7/22/92	ADDENDUM 1 - GENERAL REVISION
DATE	REVISION
STATE OF HAWAII DEPARTMENT OF TRANSPORTATION HIGHWAYS DIVISION	
SITE PLAN	
HAIKU O&M FACILITY	
INTERSTATE ROUTE H-3	
F.A.I. PROJ. NO. I-H3-1 (66)	
SCALE: 1" = 20'	DATE: JUN 1992
SHEET NO. PBI OF 28 SHEETS

HAIKU O & M FACILITY
INTERSTATE ROUTE H-3
F.A.I. PROJ. NO. I-H3-1 (66)

7/21/92	ADDENDUM I - DELETED KEYED NOTE 28
DATE	REVISION

1/22/92	APPENDUM 1 - REVISED ROOF OPENINGS FOR EXHAUST FANS AND DUCTS
DATE	REVISION
STATE OF HAWAII DEPARTMENT OF TRANSPORTATION HIGHWAYS DIVISION ARCHITECTURAL ROOF PLAN - 1B HAIKU O & M FACILITY INTERSTATE ROUTE H-3 F.A.I. PROJ. NO. I-H3-1 (66)	
SCALE: 1/8" = 1'-0"	DATE: JUN 1992
SHEET NO. PB5 OF 28 SHEETS

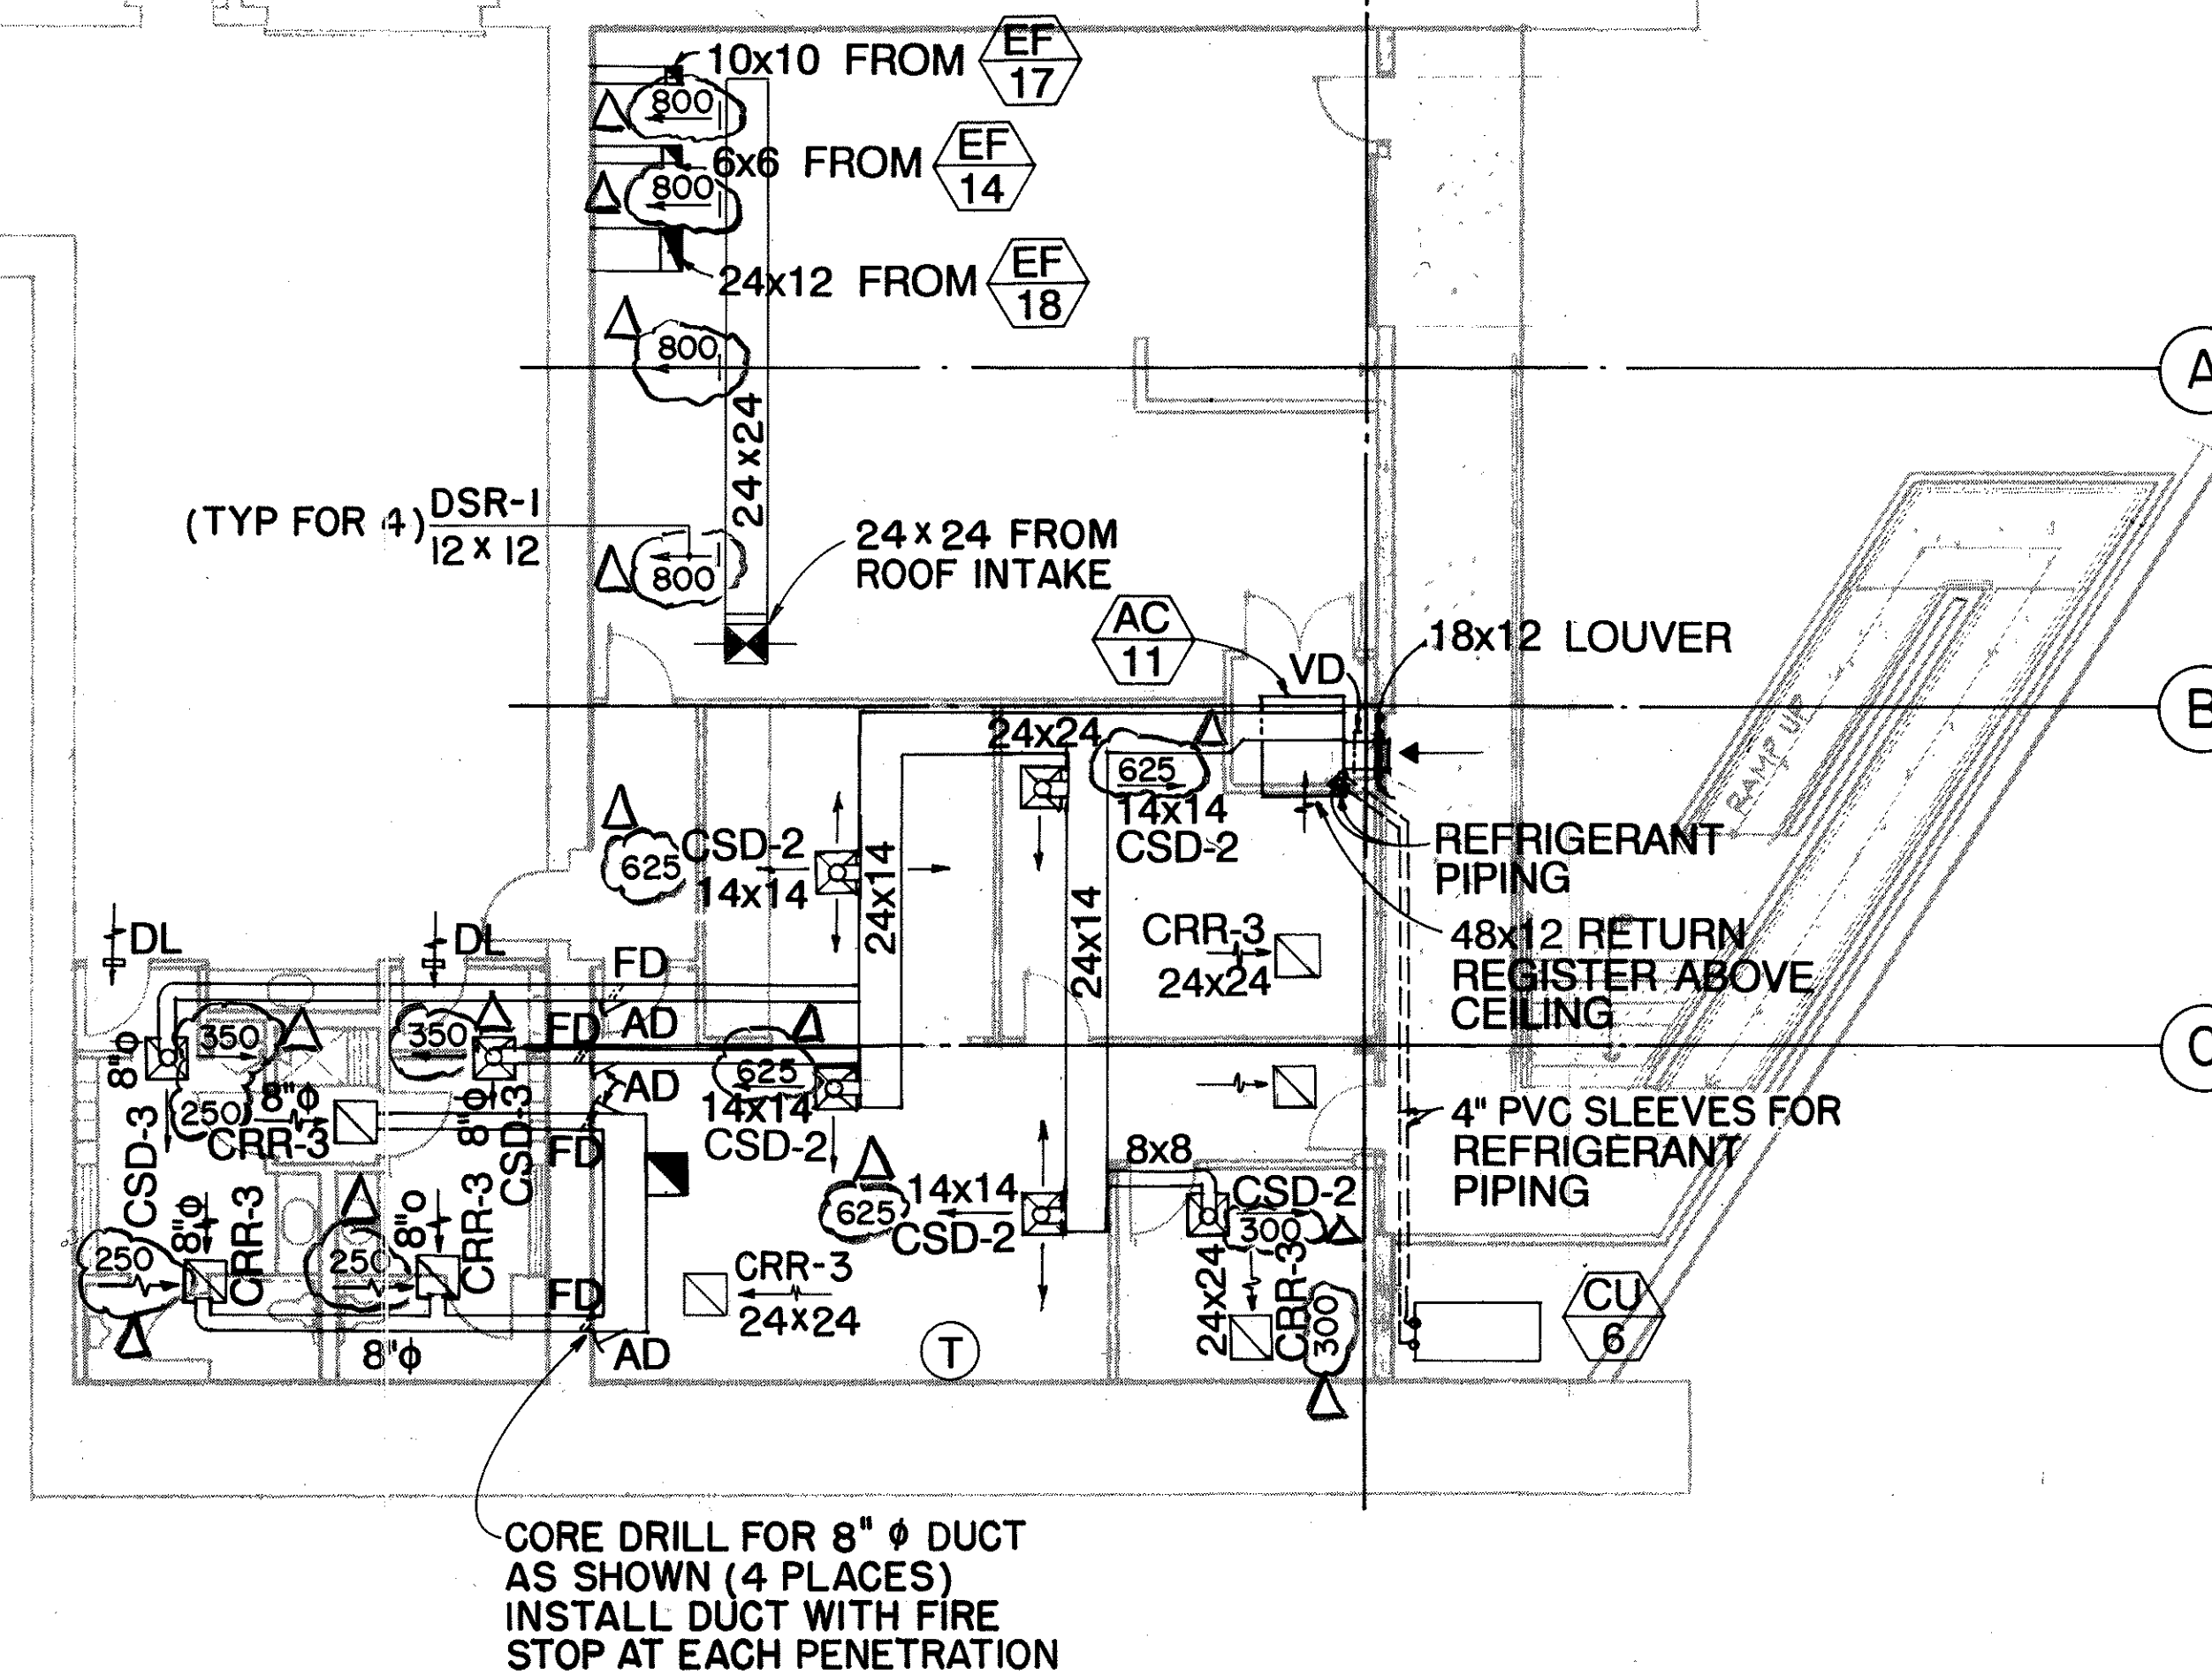
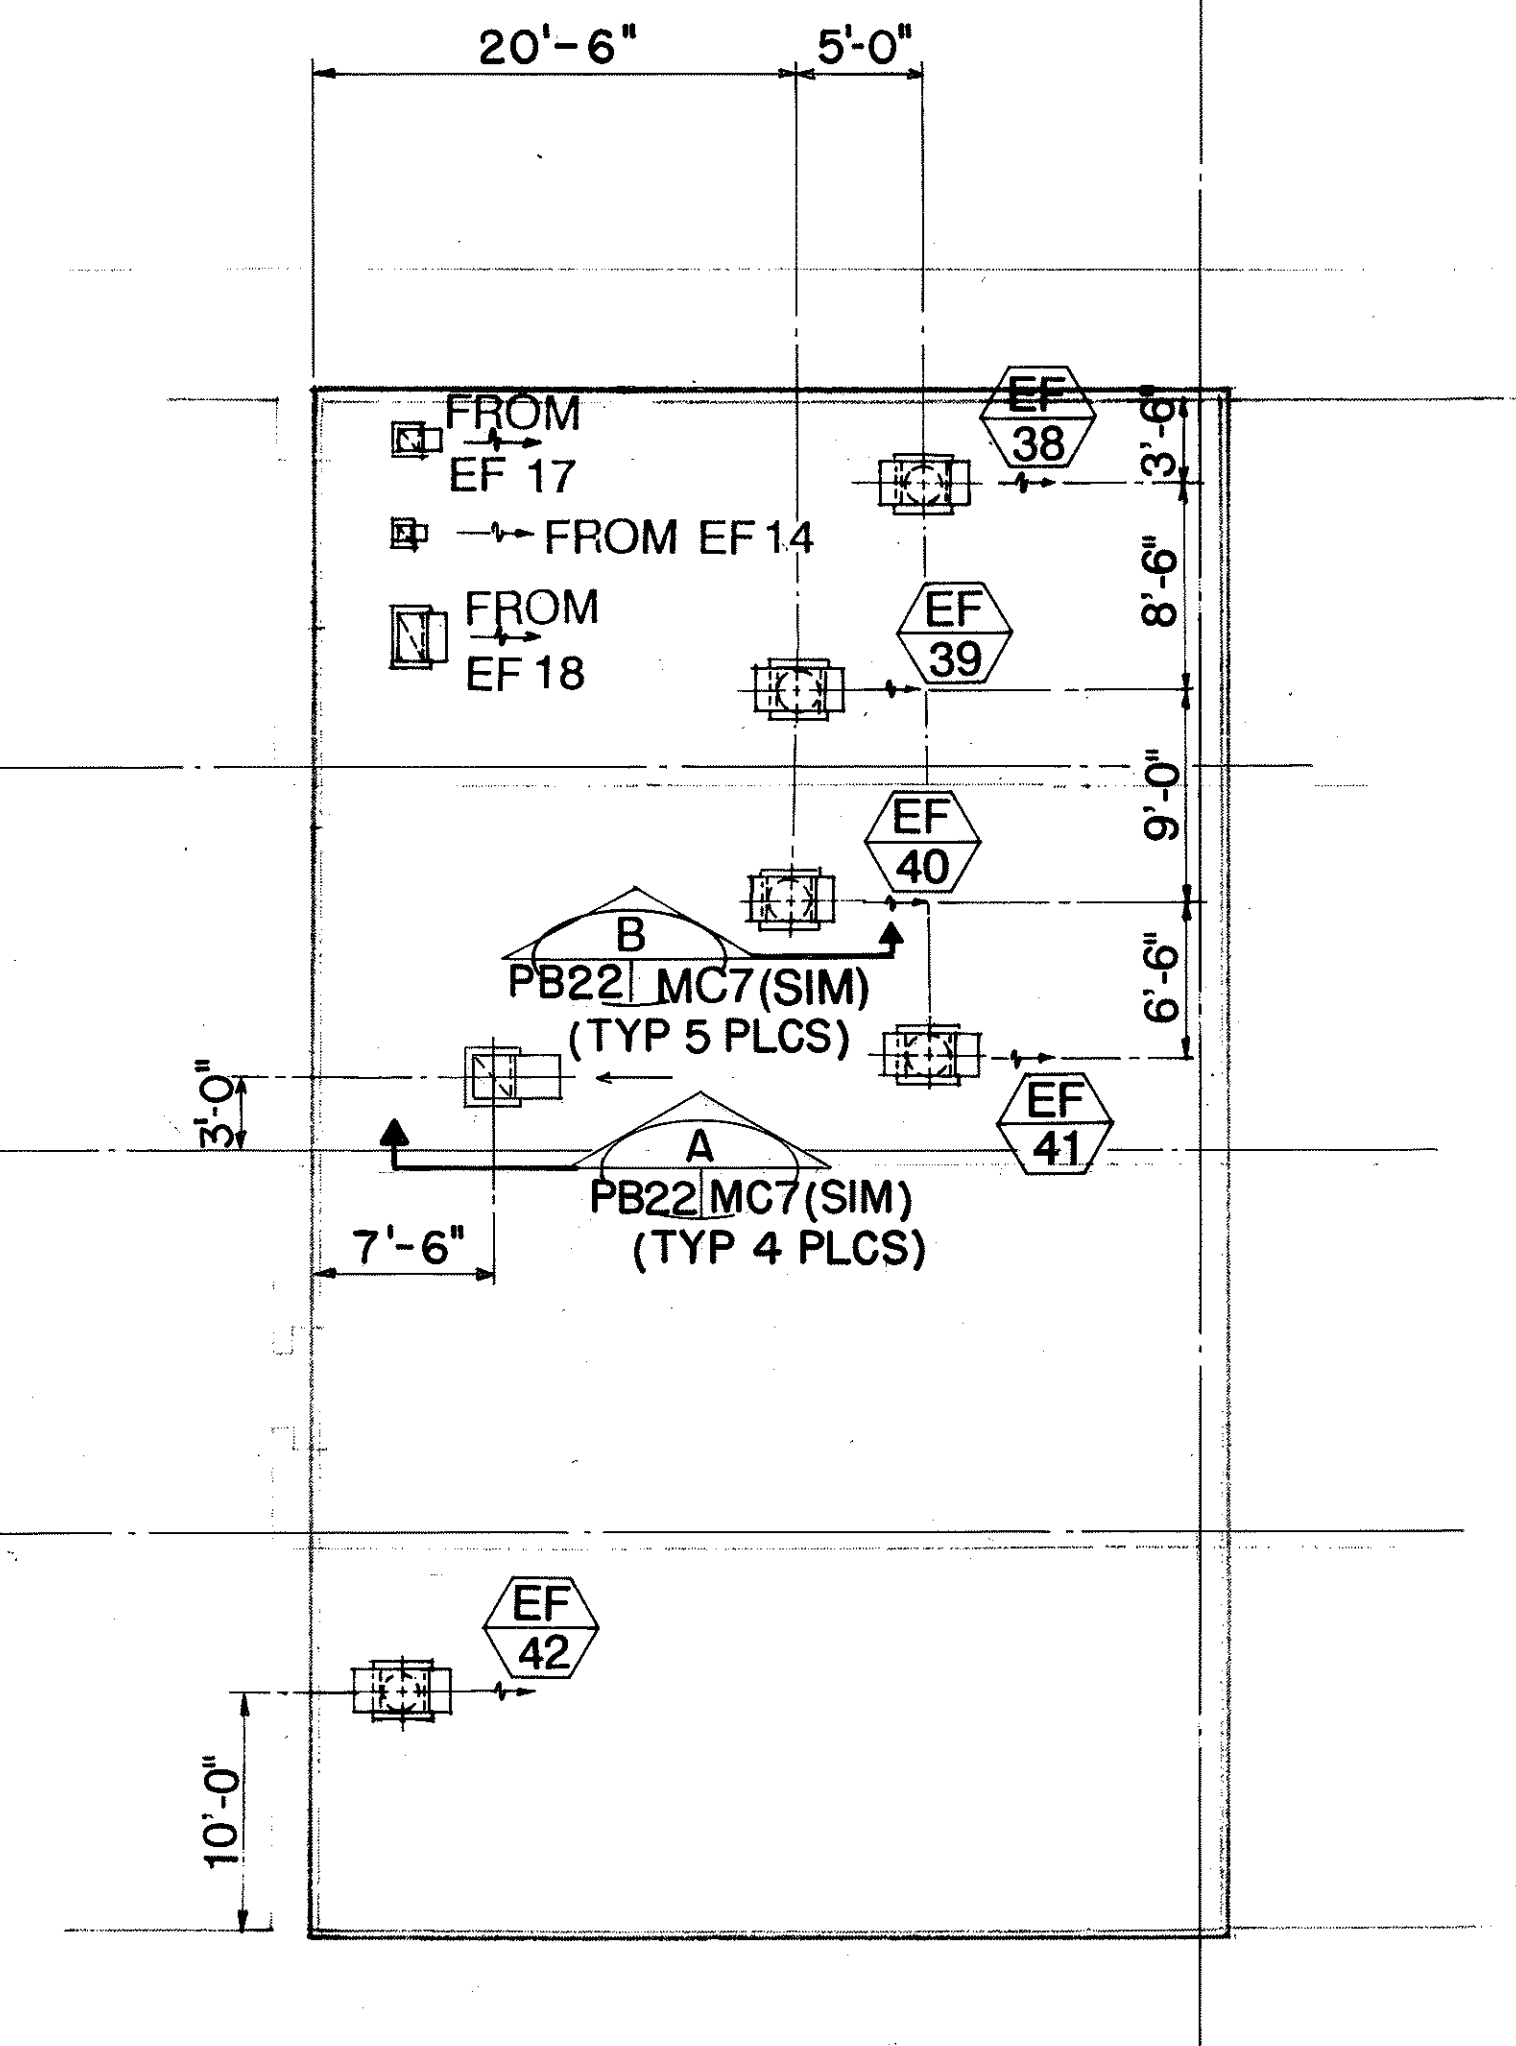
9/20/95	ADDED AIR FLOW QTY'S PER DCN 66-063
1/22/92	ADDENDUM 1 - GENERAL REVISION
DATE	REVISION
STATE OF HAWAII DEPARTMENT OF TRANSPORTATION HIGHWAYS DIVISION	
MECHANICAL HVAC-OB	
HAIKU O&M FACILITY	
INTERSTATE ROUTE H-3	
F.A.I. PROJ. NO. I-H3-1(66)	
SCALE: AS NOTED	DATE: JUN 1992
SHEET NO. PB22 OF 28 SHEETS
